**TECHNICON DESIGN GROUP INC.**

**DATE:** September 19, 2018**PROJECT NUMBER:** 72-2351-17**PROJECT NAME:** Health Partners of Western Ohio - Tiffin Community Health Center**INTENT:**

This Addendum provides modifications and clarifications to the Bid Documents dated **08/23/2018**. Bidder shall ascertain prior to submitting its Bid Form that it has received all Addenda issued and shall acknowledge receipt of each Addendum on the Bid Form.

DRAWN BY: KW  
CHECKED BY: TJH  
DATE: 10-17  
PLOT SCALE: 1:1  
JOB NO. 72-2351-17  
SHEET S101  
OF 2 SHEETS

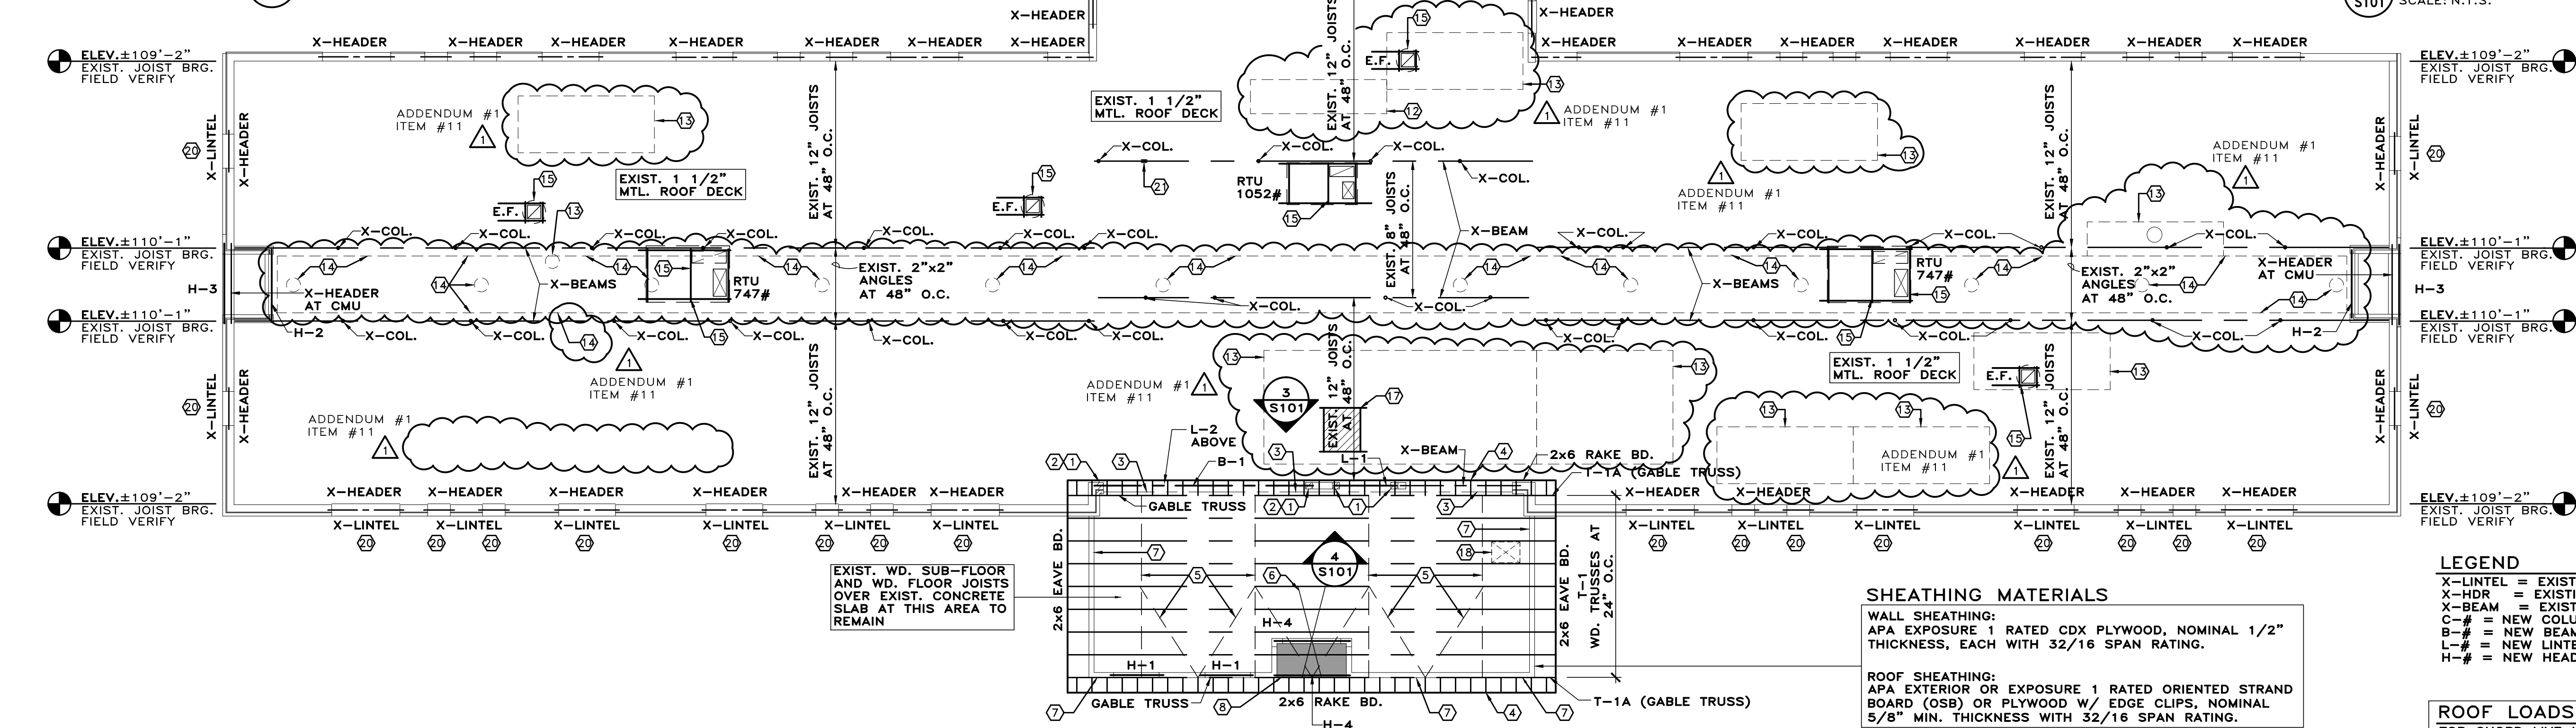
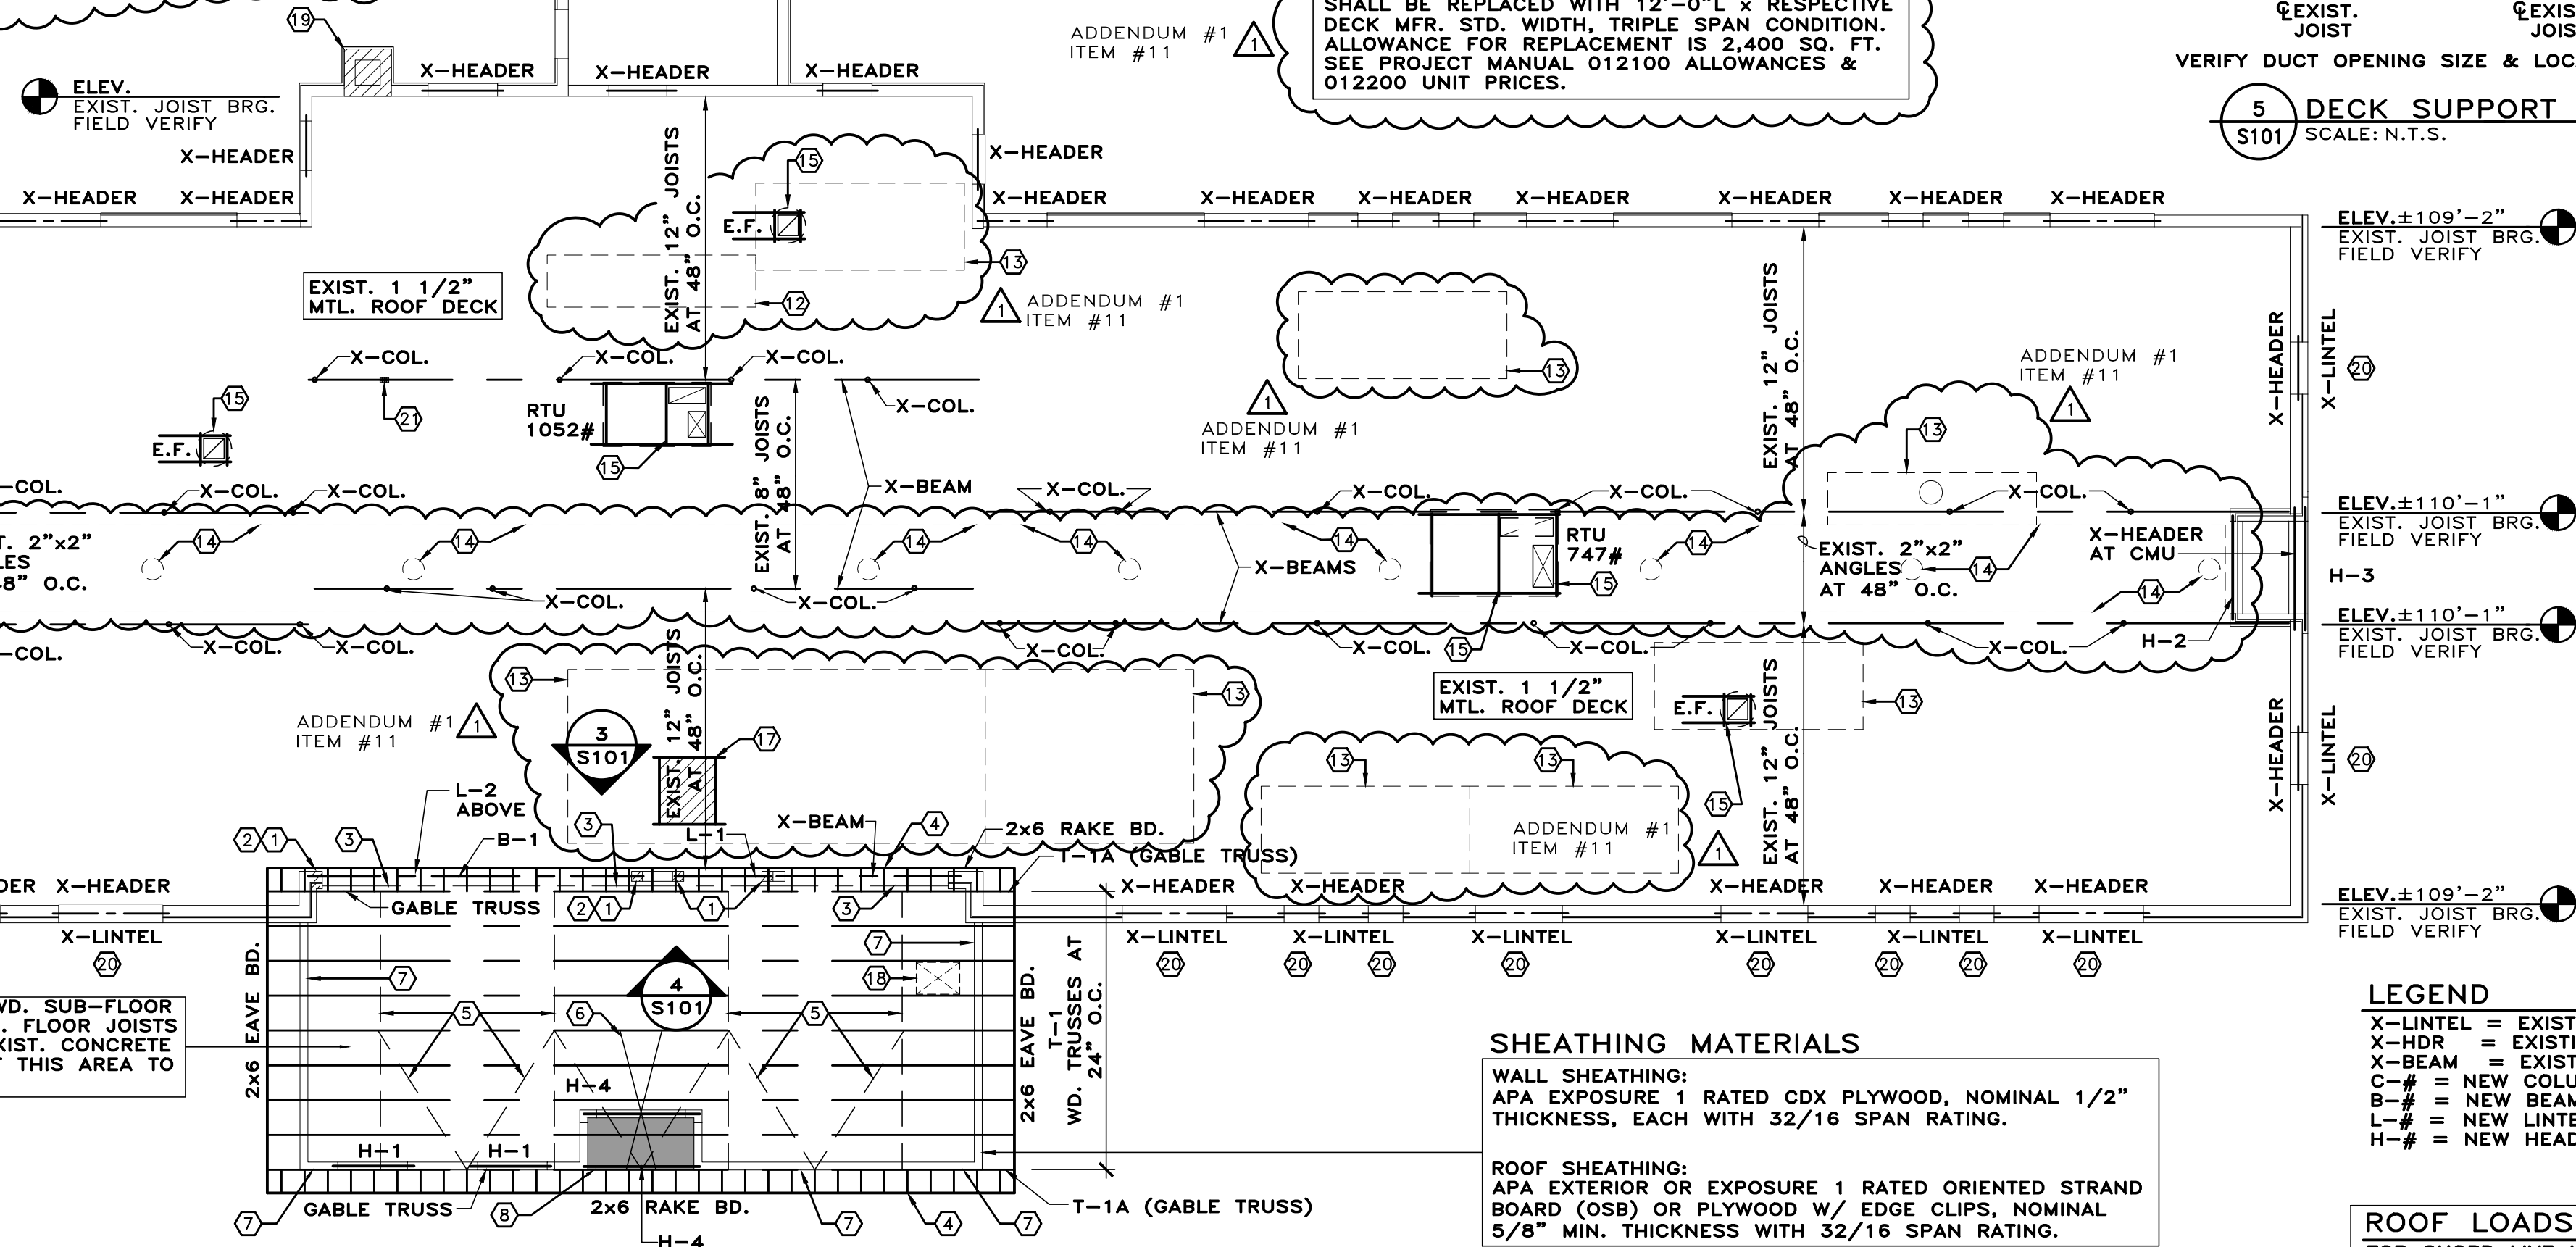
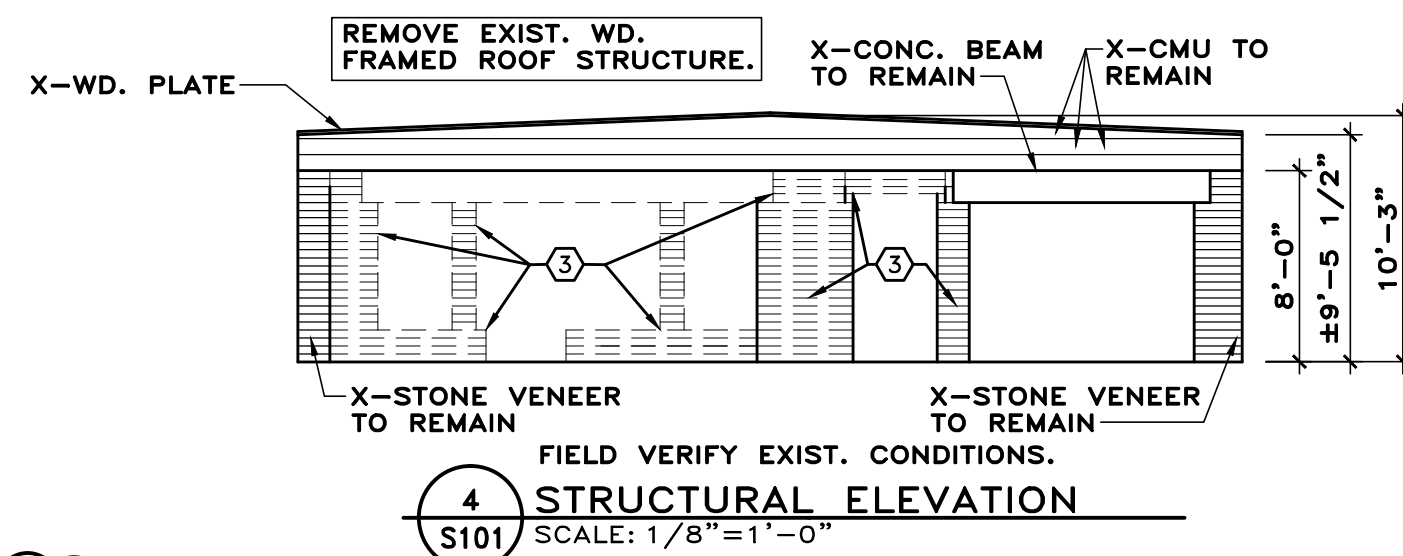
<b>ARCHITECTURAL:</b>			
12	A121 Revised sheet for Addendum 01	A121	<b>DELETE</b> current sheet A121 and <b>INSERT</b> revised sheet A121 with Issue Date 09 19 18 Addendum 01. Note that the roof deck replacement method note located below keynote 25 (in box). Also note ALTERNATE 2 that was added to this sheet below the Roof Plan regarding the installation of the vapor barrier.
13	A602-R1,2,3,4 revised sheets for Addendum 01	A602	<b>ADD:</b> See the attached window drawings for ALTERNATE 3: The Contractor shall provide a cost to furnish and install aluminum fixed storefront windows (Kawneer 451T or equal; see specification Section 084113) in lieu of the Desco 3250 Series for window types "A" thru "O" as indicated on the drawings.
<b>END OF ADDENDUM 01</b>

- REMOVE EXIST. CONC. BEAM AT EXIST. CMU.
- REMOVE EXIST. STL. COL.
- REMOVE EXIST. CMU.
- REMOVE EXIST. DECK & INSTALL NEW "B" DECK (TRIPLE SPAN CONDITION) x WIDTH REQ'D. WHERE PLMG. VENT WAS REMOVED.

- REMOVE EXIST. DECK & INSTALL NEW "B" DECK (TRIPLE SPAN CONDITION) x WIDTH REQ'D. WHERE EXIST. DECK IS SEVERLY RUSTED &/OR WHERE EXISTING ROOF PENETRATION WAS REMOVED.

- A. Allowance No. 01 – Replace existing roof deck: Include in the quantity of 2,400 square feet of Type B deck (see Section 053100, paragraph 2.2) as indicated on roof framing plan on sheet S101. Minimum replacement area is 12-0 +/- triple span condition by the deck manufacturer's standard width.

1. Description: Unit Cost for replacement of existing metal deck that is deemed necessary to replace with new 22 gauge primed metal deck (per deck manufacturer's standard deck panel width) x 12'0" l. (triple span condition). Attached to roof joists/framing as indicated on sheet S101 Detail 6/S101.
2. Unit Of Measurement: Per square foot.
3. Quality Assurance: Price with allowance adjustment requirements in General Requirement "Allowance." Allow the square footage of metal roof deck replacement as indicated in Section 012100 "Allowances" and on roof plan indicated on Sheet S101.

ADDENDUM 1  
ITEM #13  
ALTERNATE #3

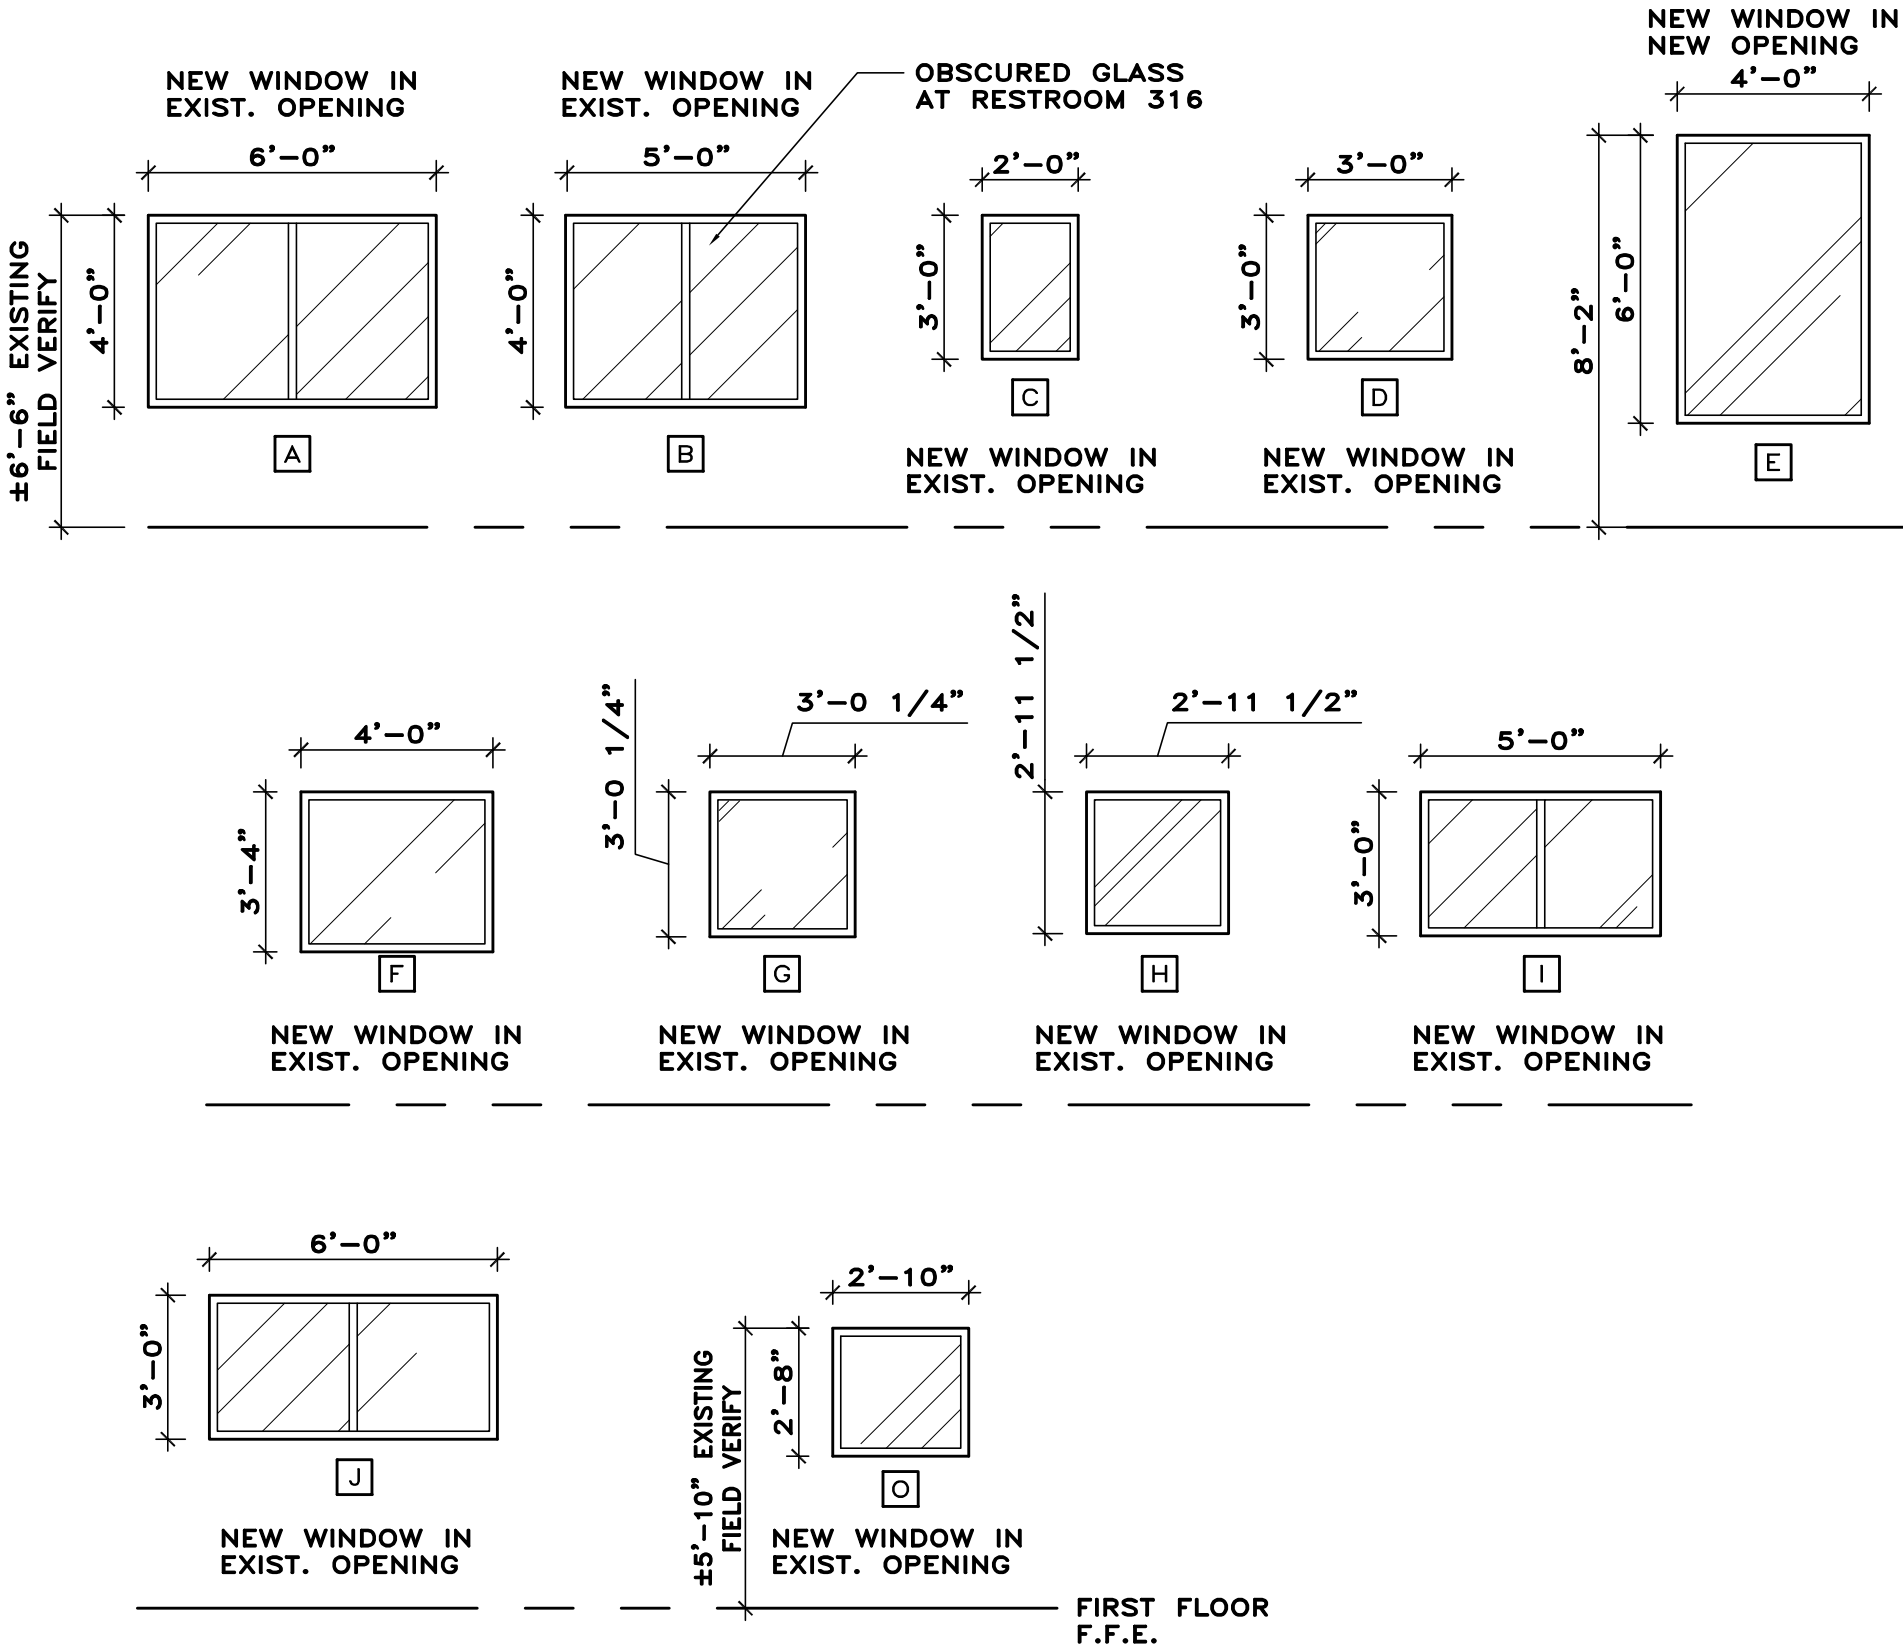
THERMALLY BROKEN ALUMINUM WINDOW FRAME W/ 1" INSUL.  
LOW-E SOLAR BAN 60 GLAZING. KAWNEER 451T 4 1/2" x 2" FACE.  
FRAME FINISH: ANODIZED, COLOR: DARK BRONZE.  
BASIS OF DESIGN: KAWNEER 451T  
SEE PROJECT MANUAL FOR APPROVED EQUALS.

- C. ALTERNATE 3: The Contractor shall provide a cost to furnish and install aluminum fixed storefront windows (Kawneer 451T or equal; see specification section 084113) in lieu of the Desco 3250 Series for window types "A" thru "O" as indicated on sheet A602 of the drawings. Install fixed storefront windows according to contract documents and manufacturer's requirements.
